DATE: February 11, 2014
TO: Honorable Mayor and Members of the Village Council
FROM: John C. Gilbert, Village Manager
RE: Site Plan Review: 12-22-24 Crandon Boulevard and 51 Harbor Drive

DT: February 11, 2014
TO: John C. Gilbert, Village Manager
FR: Jud Kurlancheek, AICP, Director
Building, Zoning, and Planning Department
RE: Supplemental Site Plan Review Report and
Recommendation: 12-22-24 Crandon Boulevard and 51
Harbor Drive

DT: December 3, 2013
TO: John C. Gilbert, Village Manager
FR: Jud Kurlancheek, AICP, Director
Building, Zoning, and Planning Department
RE: Site Plan Review: 12-22-24 Crandon Boulevard
with access from 51 Harbor Drive

SHEET NUMBER: **C-2**

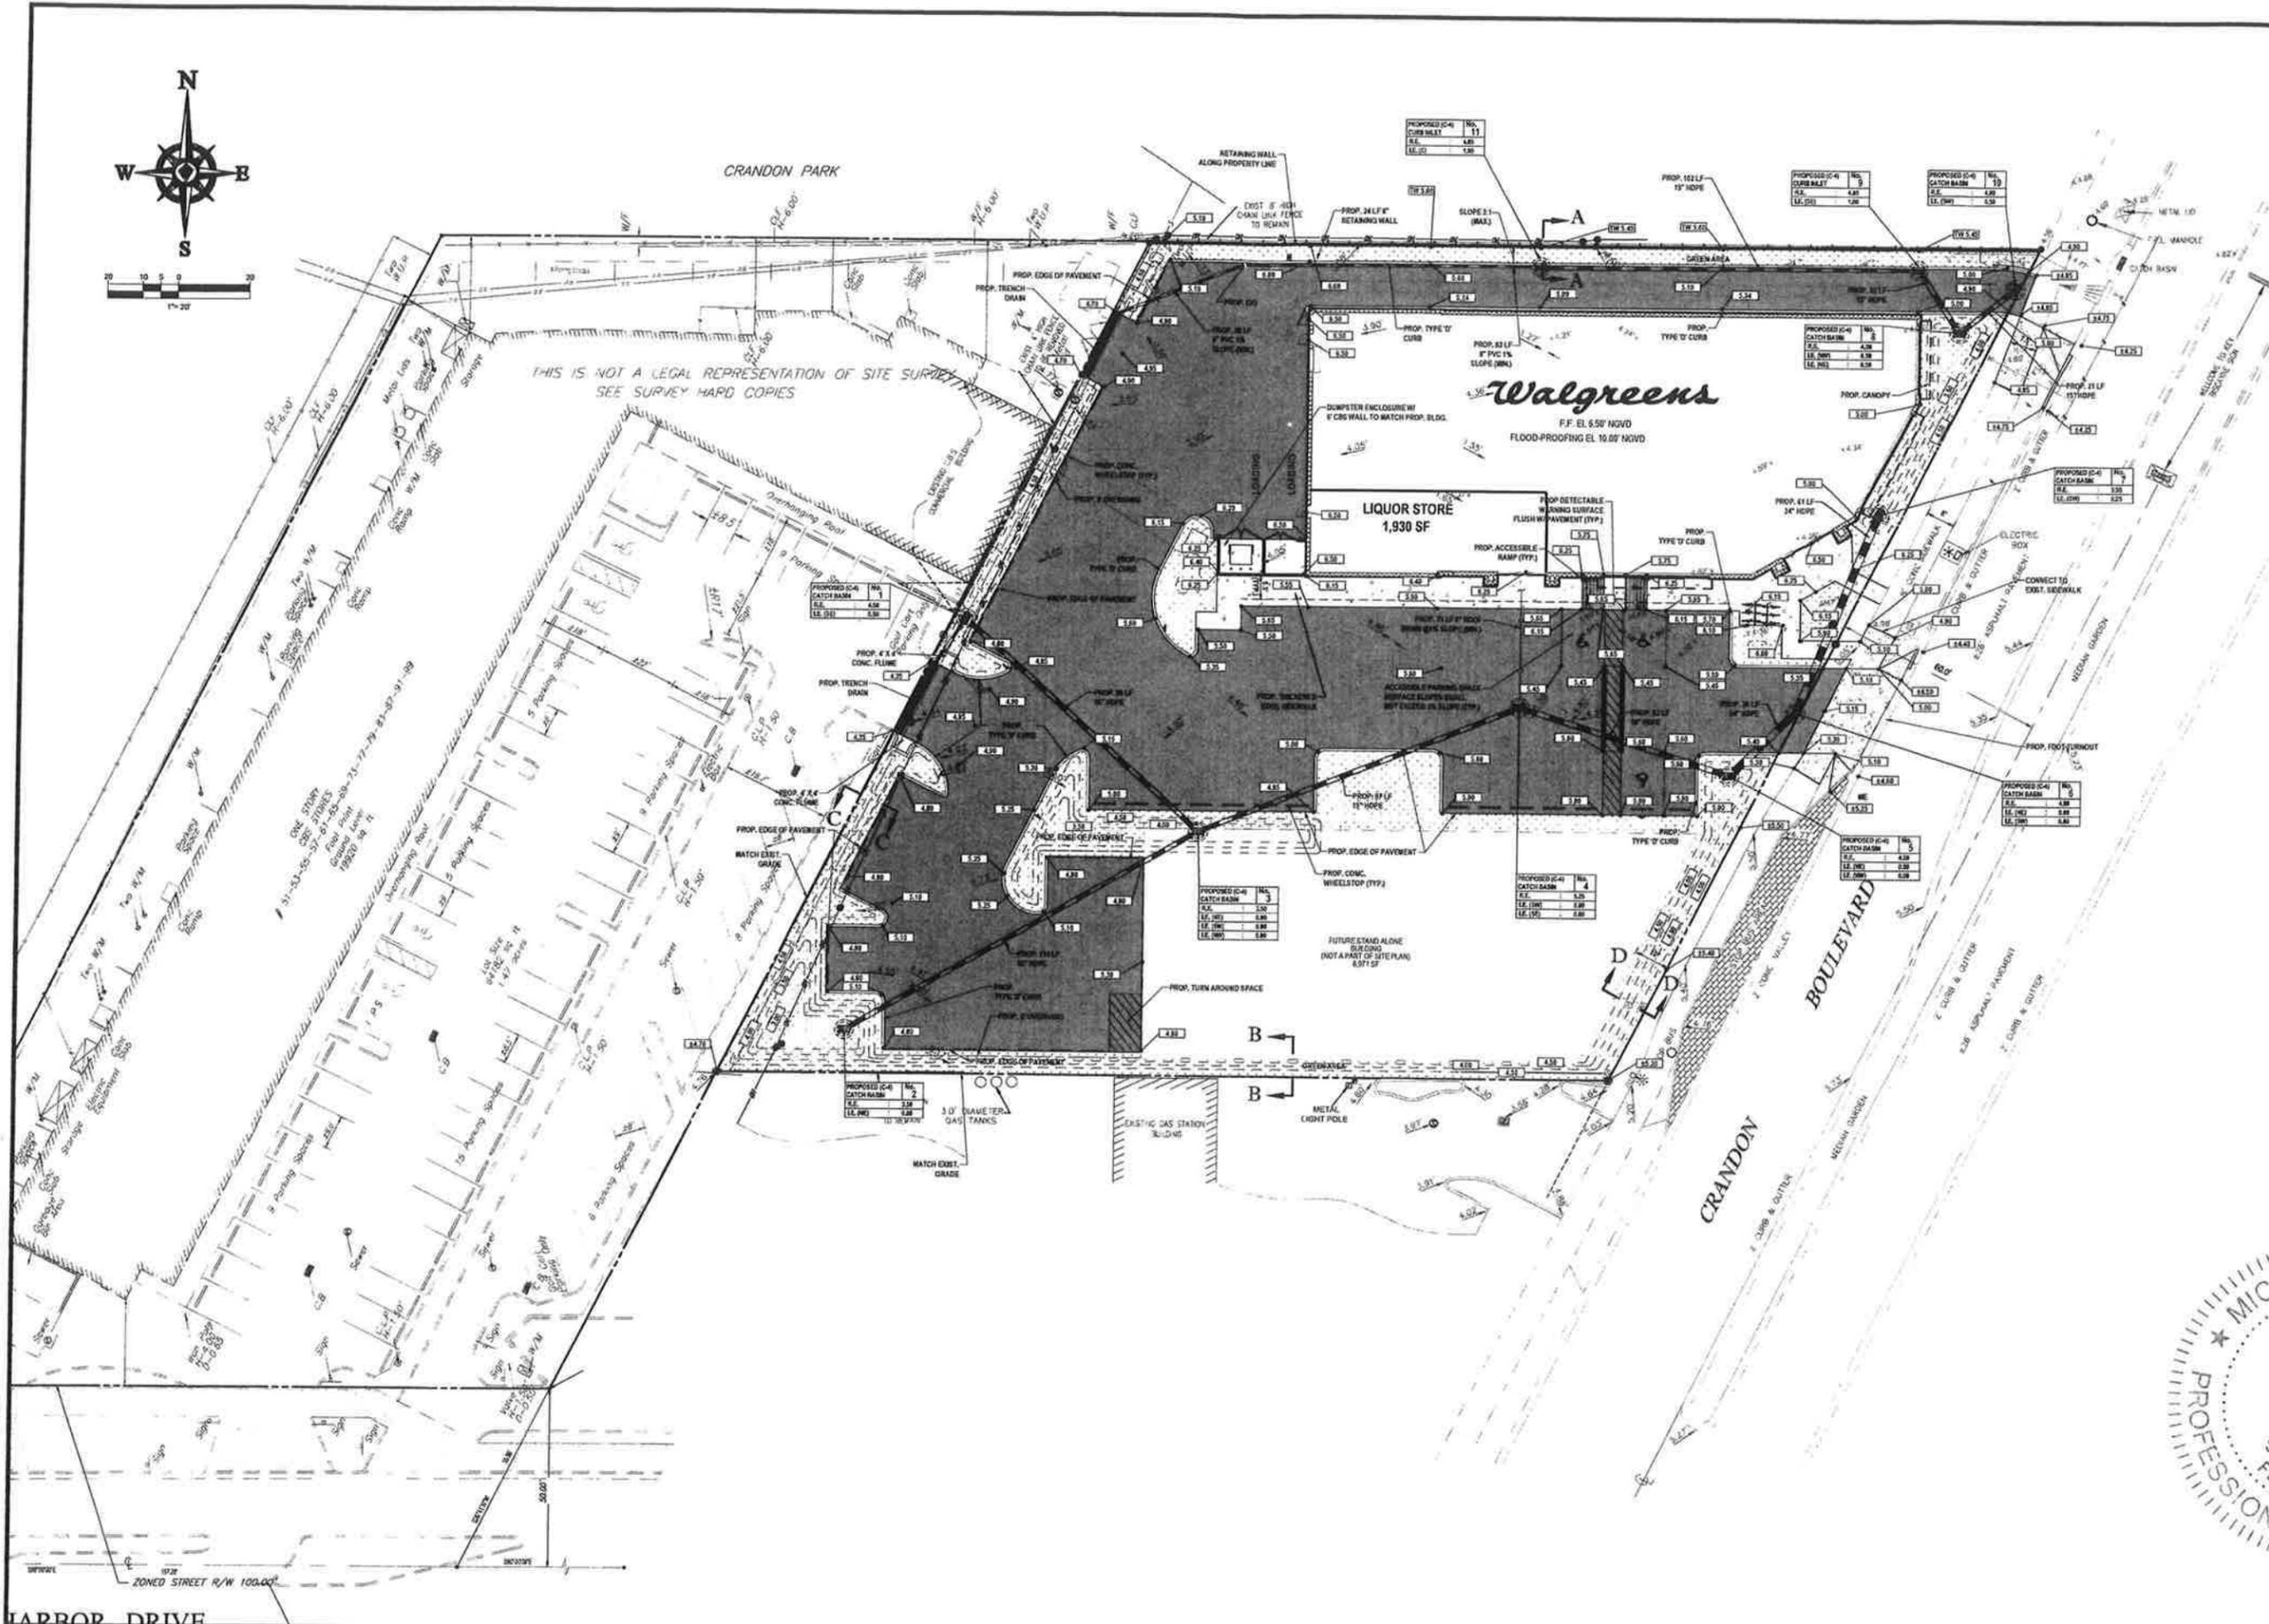
6. Label edging for the dead end of the parking lot adjacent to the Future Building Area on C-1 – Type D curb?
7. Per the Grading & Drainage Plan, Sheet C-2, runoff from 51 Harbor Drive is coming into the 12-22-24 Crandon Blvd. property at the west perimeter. Provide drainage divides to block runoff from 51 Harbor Drive.

CADD PLOT: 1226	SCALE: 1/8" = 1'-0"	DRAWING NO.
VOID PLOT:	DRAWN BY: Author	A1.11
SUPERSEDES PLAN DATED:	DATE: 03/01/2013	
	REVIEWED BY: ACS II	OF DWGS.

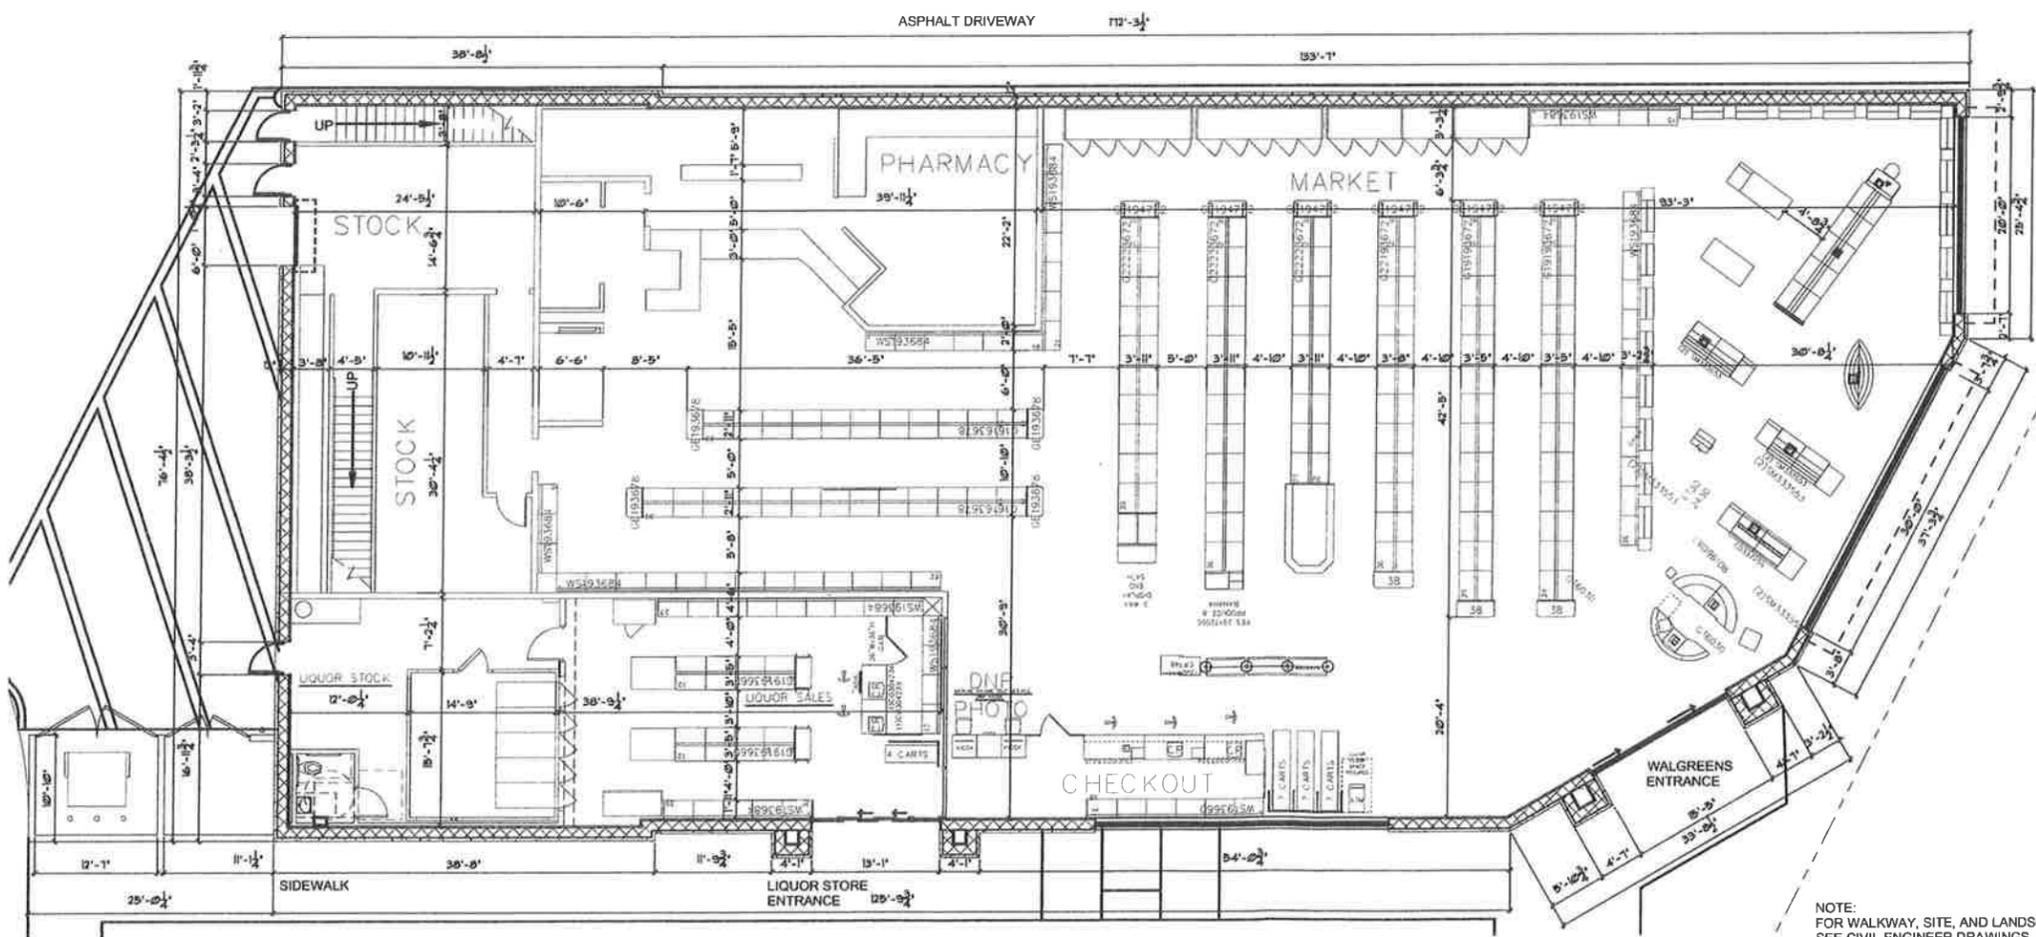
1. On Site Plan Sh. C-1, Floor Plan Sh. A1.11, and any sheet that references the mezzanine, change "Mezzanine" to "Mezzanine Storage", both in plans and tabulations.

Intersection 1 Existing vs Safe Visibility

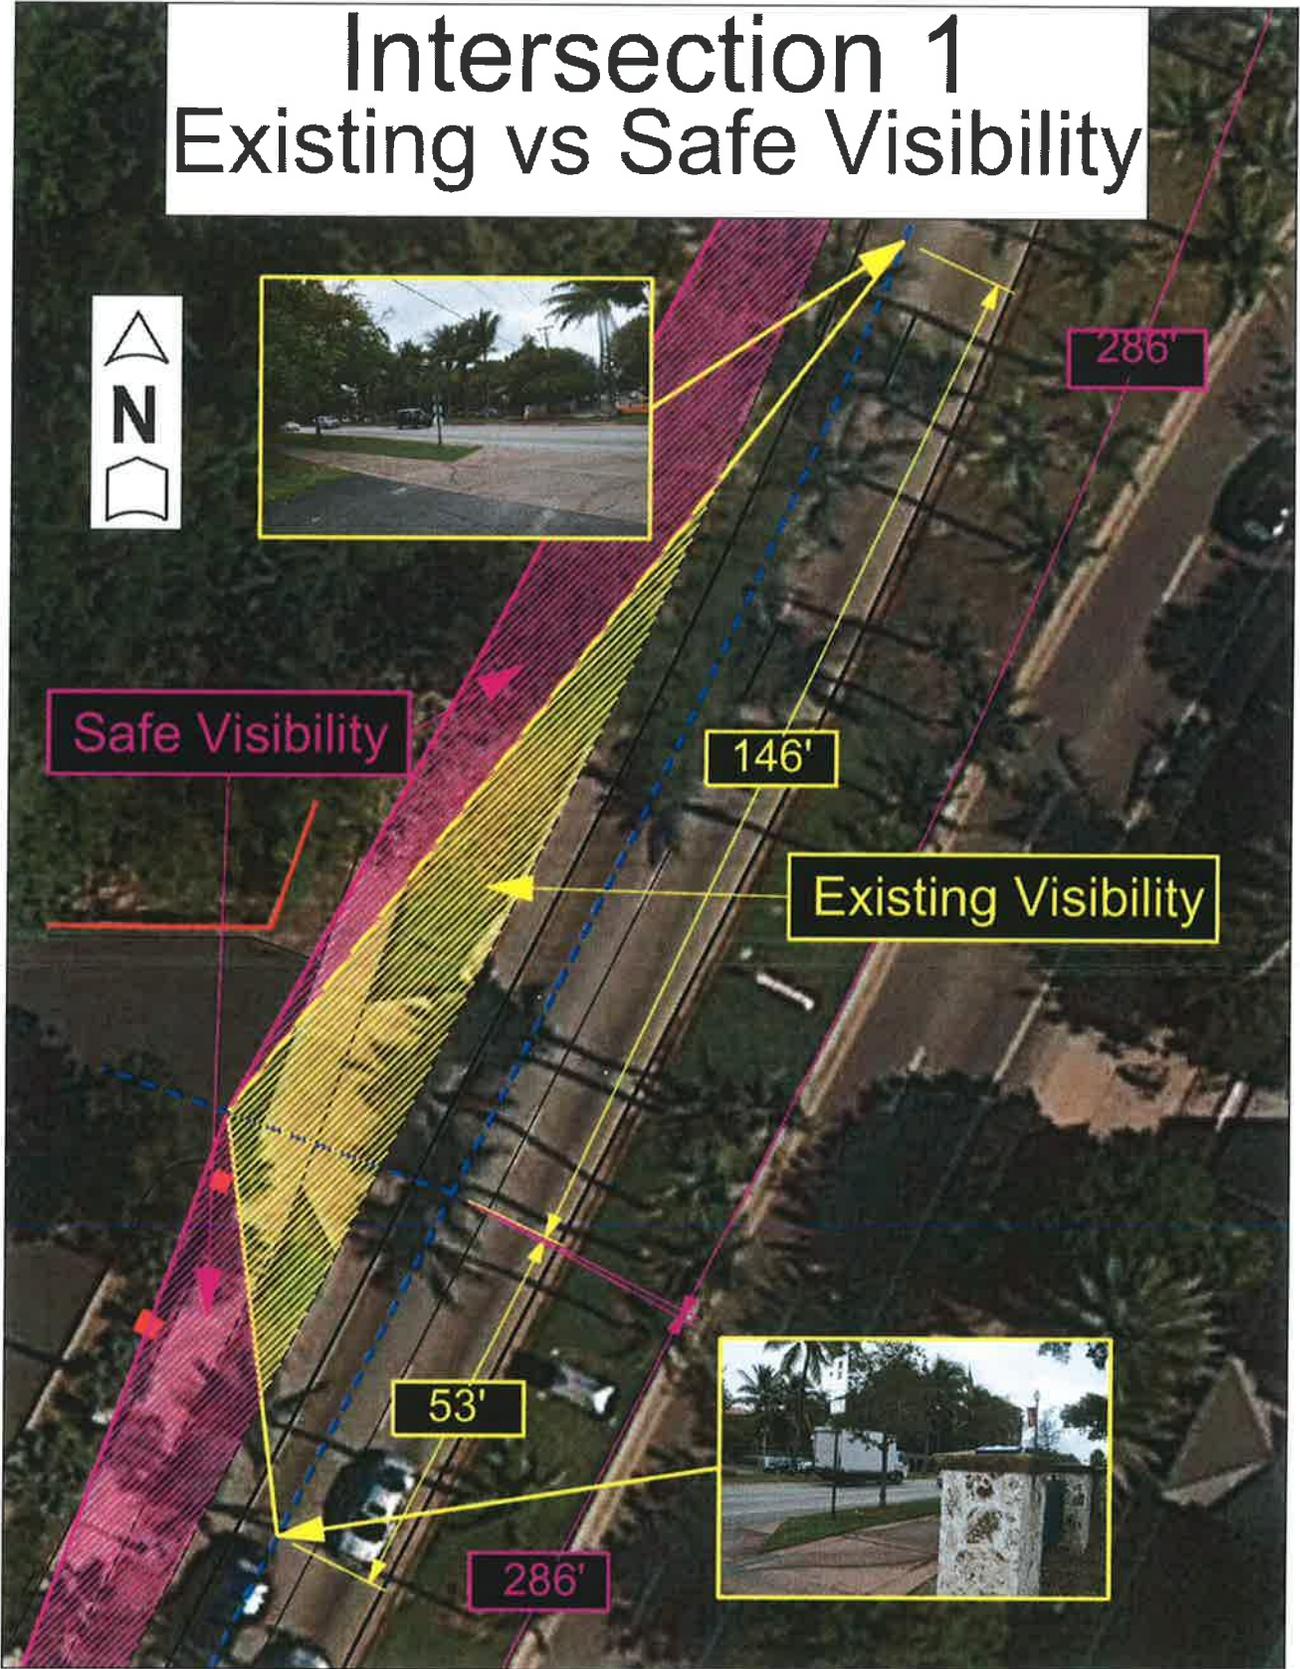
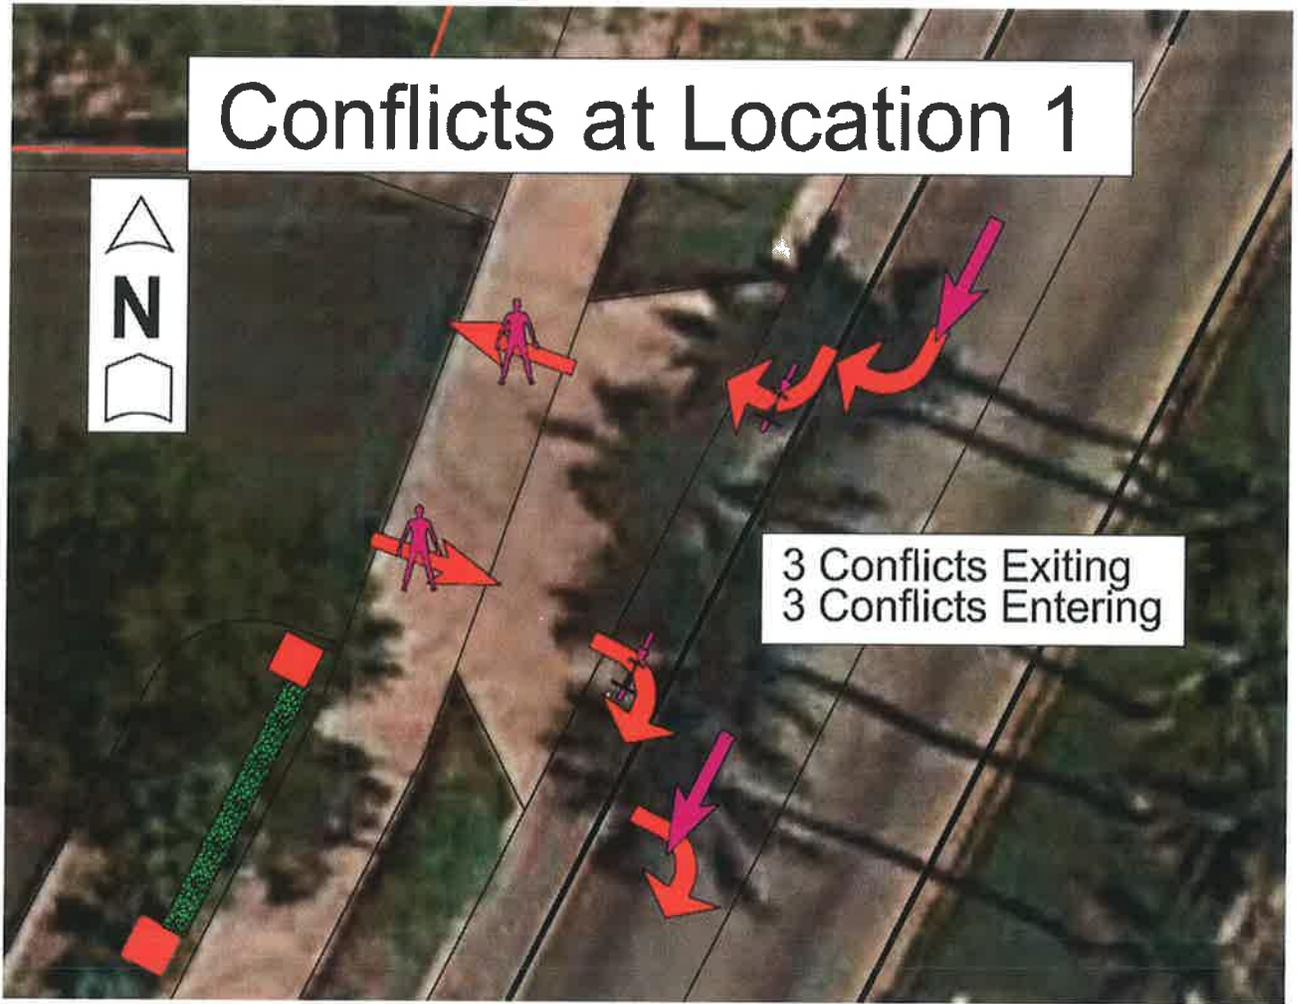
Exhibit 12 shows the visibility concerns with this location and **Exhibit 13** shows the various potential collisions at this location.
